NEEDS FOR AND ALTERNATIVES TO (NFAT)

La Capra Associates Undertaking # 108

La Capra to redo Figure 9-99U

UPDATED Figure 9-99U: Value of PDP Components – 78 Year NPV vs. All Gas

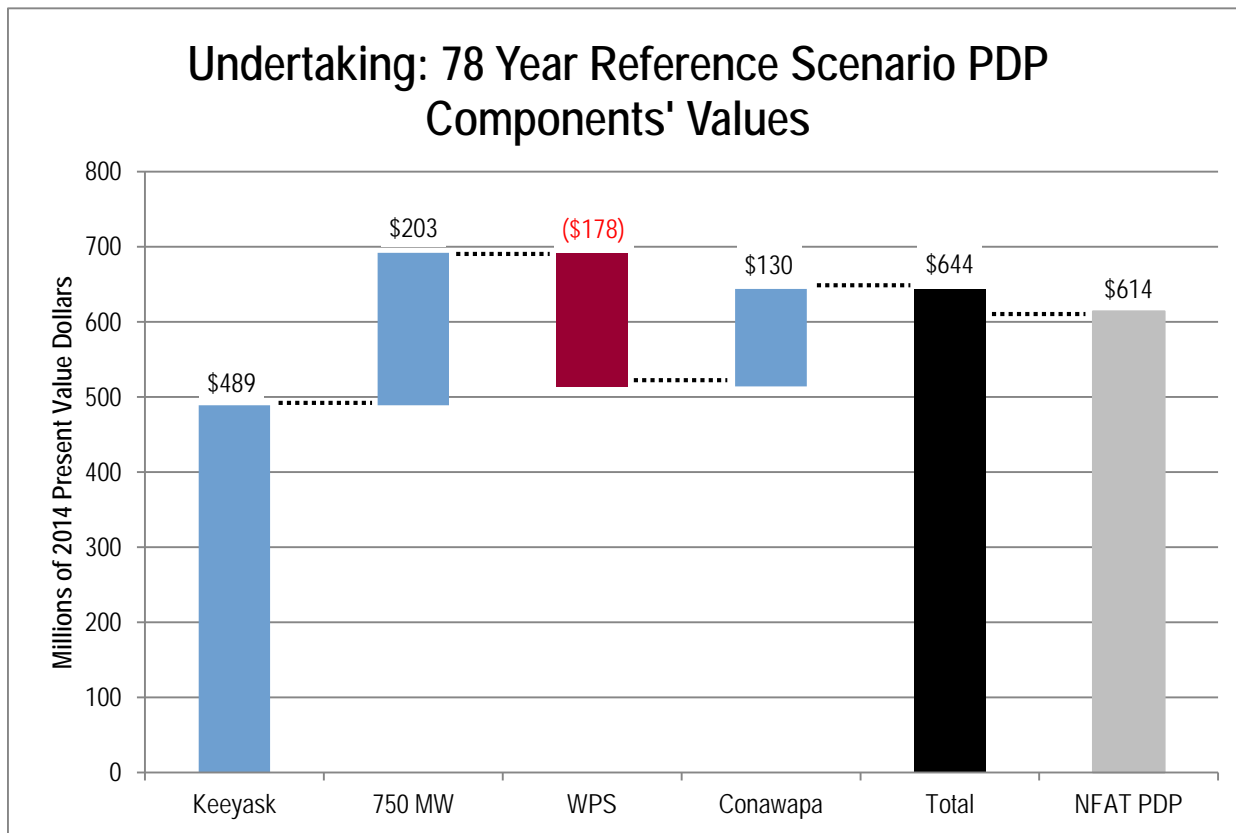
La Capra Associates notes that the economics of the WPS Sale represented in this analysis implies that the WPS Sale is expected to increase net costs to MH (by \$178 million), This is when the WPS Sale is added to a system without Keeyask and Conawapa, thus requiring a change in thermal generating capacity, and if MH still needs to make the investment in the US-side transmission line that at one time WPS was expected to make. The original 9-99U contained within the Addendum showed the WPS contract to have a benefit (i.e., lowers MH costs) of \$6 million. The difference of \$184 million is the present value of the investment in the US side of the 750 MW transmission project that at one time WPS was expected to make.

A revision of Figure 9-99U is included below. This version removes the 250MW transmission incremental cost. These values are MH 2012 Reference Case Assumptions with updated capital costs for Keeyask and Conawapa.
